Interactive comment on “Future hydrological extremes: the uncertainty from multiple global climate and global hydrological models” by I. Giuntoli et al.

Referee 3 Antonio Speranza Received and published: 2 March 2015

Fig. 1. Mean annual daily runoff (1972-2005) per GHM (in row) for selected gridcells (Lat, Lon): A-Tropical (-2.25,-53.25); B-Arid (-20,25); C-Temperate (43.75,11.25); D-Snow (41.65,-91.5); E-Polar (65,165).

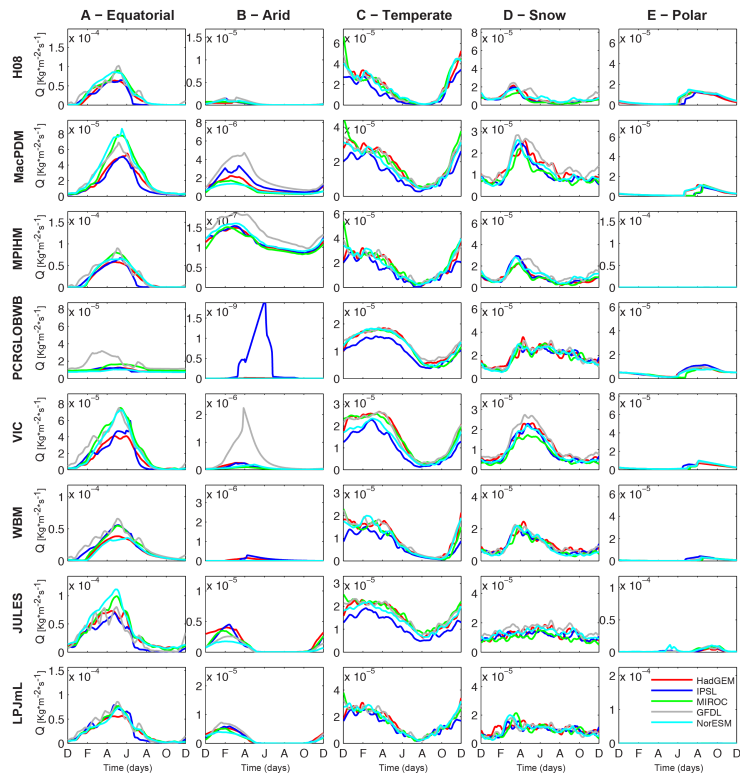
Comment-1 The addressed topic is interesting and quite a bit of performed work is reported in the paper; in particular, I appreciated the effort in assessing the relative contribution of GCMs and GHMs to “uncertainty”. I think, however, the reader could be helped in forming his own judgement if some more information was provided here and there; for example, by showing specific examples (giving an idea of the nature of analysed fields) of runoff fields for different models.

Answer We thank the reviewer for the positive and helpful suggestions. As suggested, we could provide in Annex a specific example of mean annual runoff from the control period for five representative gridcells (Fig.1) i.e. one per main Koppen Geiger region (A-Tropical, B-Arid, C-Temperate, D-Cold, E-Polar) for the different global model combinations i.e. GCMs-GHMs.
